PLANNING COMMISSION MEETING

February 25, 2026 – 6:00 PM

MEETING DATE: February 25, 2026
TO: Planning Commission
STAFF ORIGINATOR: Steven Gilmore, AICP, Assistant Community Development Director
AGENDA ITEM: PUBLIC HEARING - Hidden Creek South Preliminary Plat and Planned Unit Development
60-Day Deadline: April 21, 2026

Headwaters Land Group, represented by Mr. John Dobbs, has submitted applications for a Preliminary Plat and Planned Unit Development (PUD) Amendment for Hidden Creek South. The subject property consists of approximately 56.52 gross acres located south of Headwaters Parkway within the Headwaters Master Planned Unit Development (PUD) area.

WOODLAND PRESERVATION PLAN

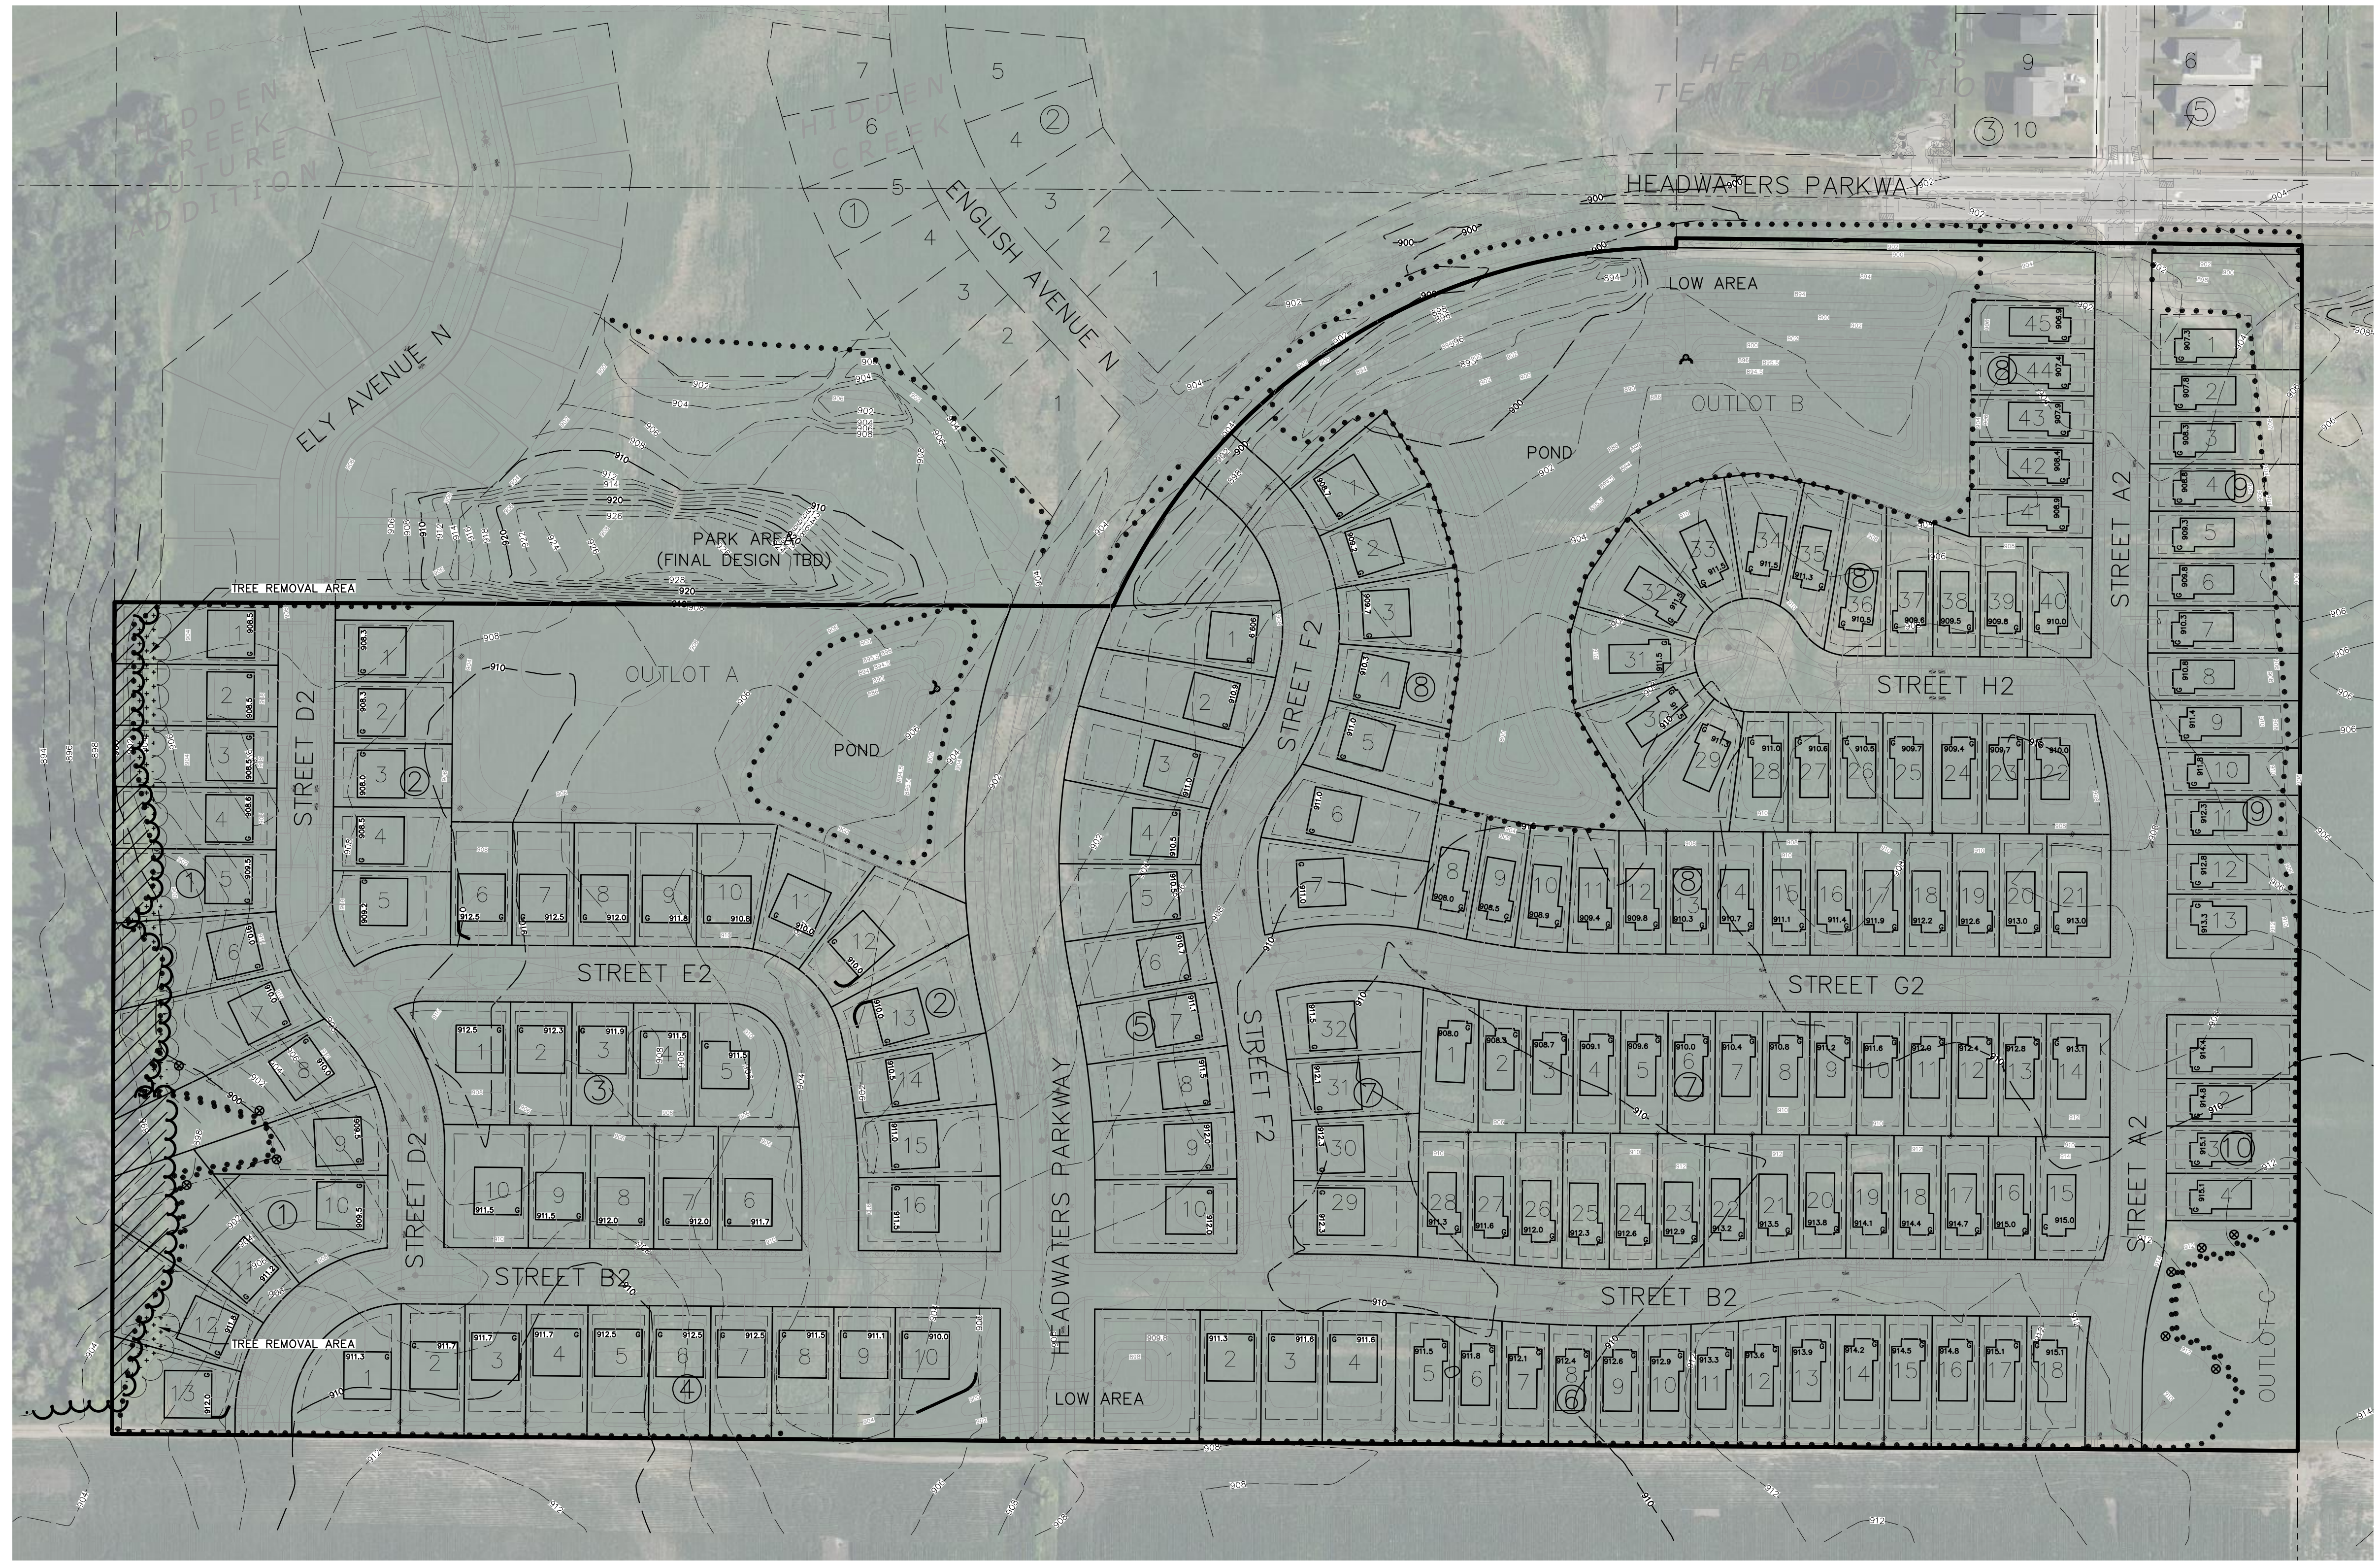
Sheet T1 Woodland Preservation Plan
